Solar park and battery storage facility on

LAND TO THE NORTH OF THE FORMER MAELOR GAS WORKS, WREXHAM

NRW ref: CAS-159593-COF7 - LPA ref: P/2021/0676

1 *Background*

Figure 4-5: Location of the “river” model nodes.

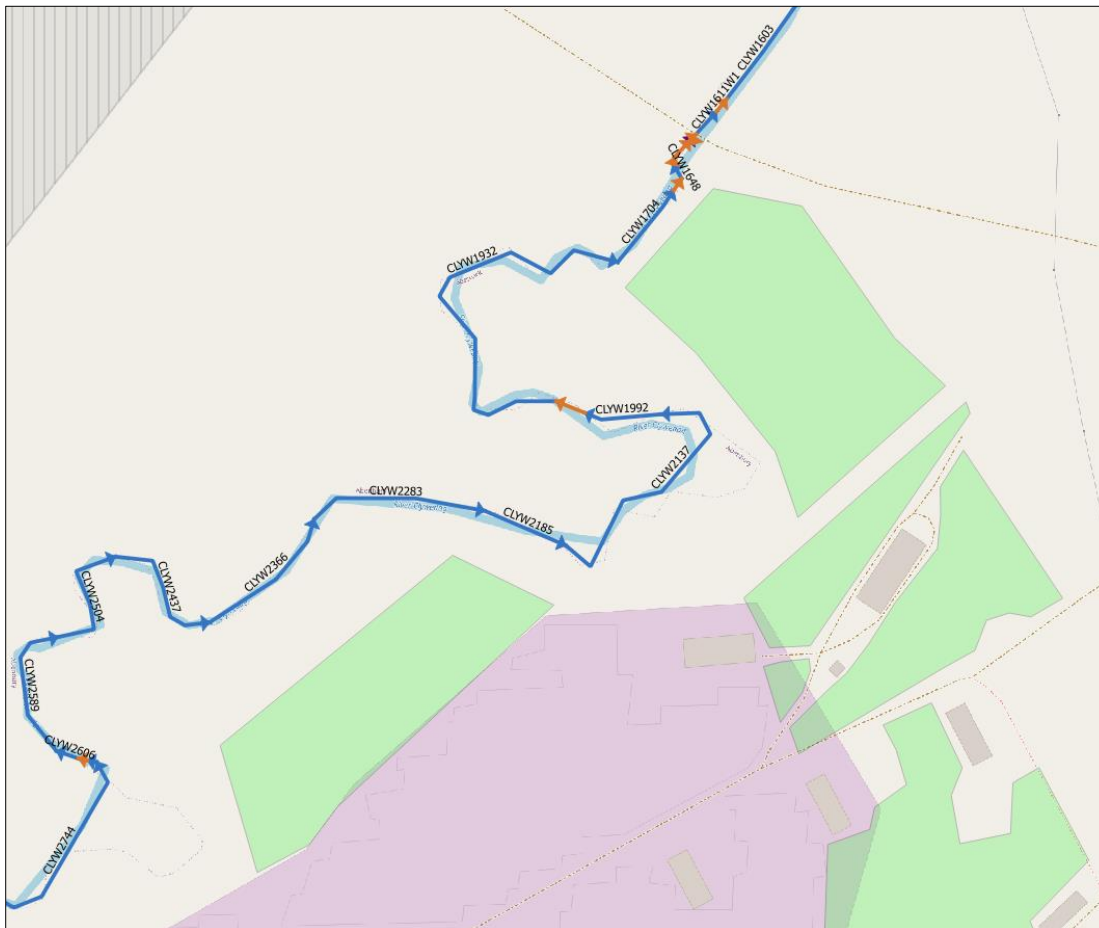
The maximum increase in levels occurs within the area of solar panels; this is generally between 0.02 and 0.04 m for (Floodplain Node 2) for the 1% and 0.1% AEP respectively (Tables 4-2 and 4-3 of the FCA v2i_210514) with an absolute grid/node maximum of 0.08 m. The increase in flood levels declines as one moves away from the area of solar panels notably towards the River Clywedog. The increase in river levels for the 1%CC AEP is shown in Table 4-4 reproduced below. This is a maximum of 0.008 m (8 mm) for river node CLWY1992 but is quite localised.

we would argue that such increases are acceptable and that **no further mitigation is required**.

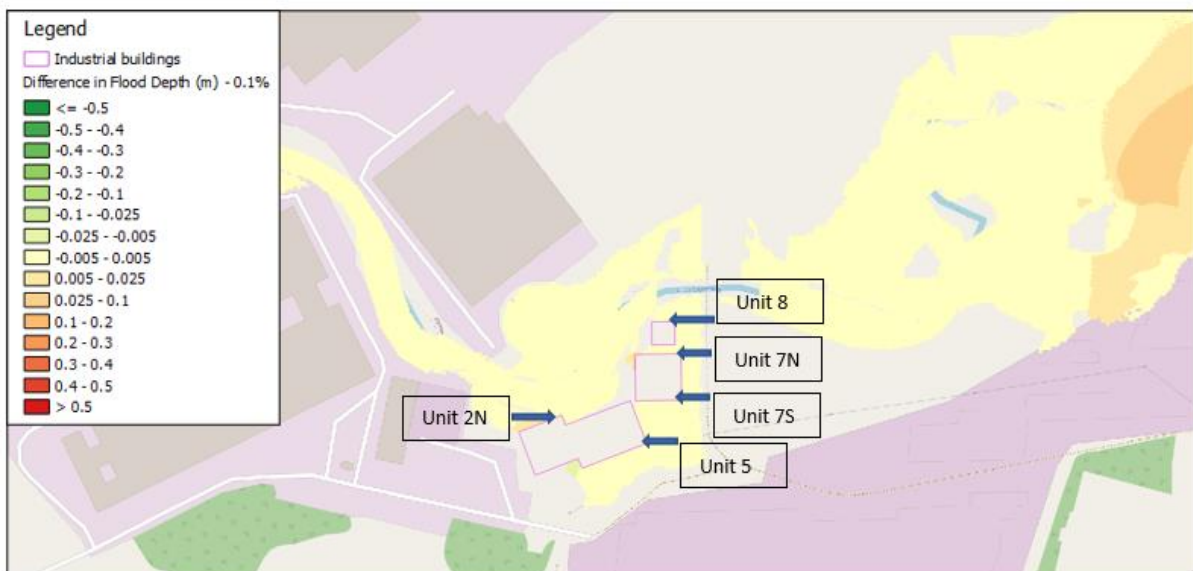
It is, though, rather confusing that the map in the FCA showed increases at the captioned locations. These increases are due to two factors:

- Firstly, in the interests of economy, we have undertaken post-development model runs for two planning applications jointly. The applications are the captioned solar farm and that for an industrial development on land to the west of the causeway.
- Secondly, the increases that are shown are due to model instability that is due to an erratic bed profile of the River Clywedog at that location.

Figure 4-7: Change in flood levels due to development (0.1% AEP)

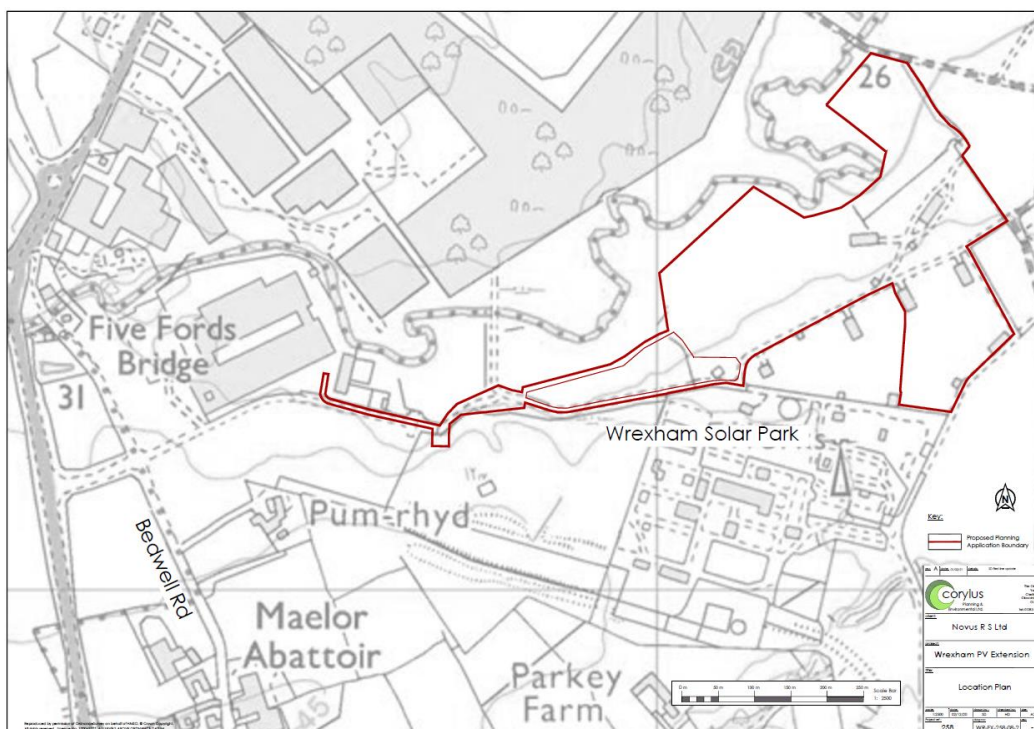
Further modelling has been undertaken during 2021 for the adjacent (Industrial) Site, in line with **Version “C”** as per Table 1-1 from the FCA (v2i_210514), reproduced below. This modelling work has not yet been submitted; however, the work completed thus far has investigated the unusual channel configuration in this section of the model. The helpful comments made by NRW on the model and our response are shown in Table B-1. Modifications have been made to the model which lead to flood level differences of <0.005 m (5 mm), as shown below in Figure 4-7 of the draft FCA for the Industrial Site.

This confirms that the proposed solar development (nor the Industrial Development) would have **no practical impact on flood levels near the Mainetti factory**, a conclusion which accords with the hydraulics of the Site.
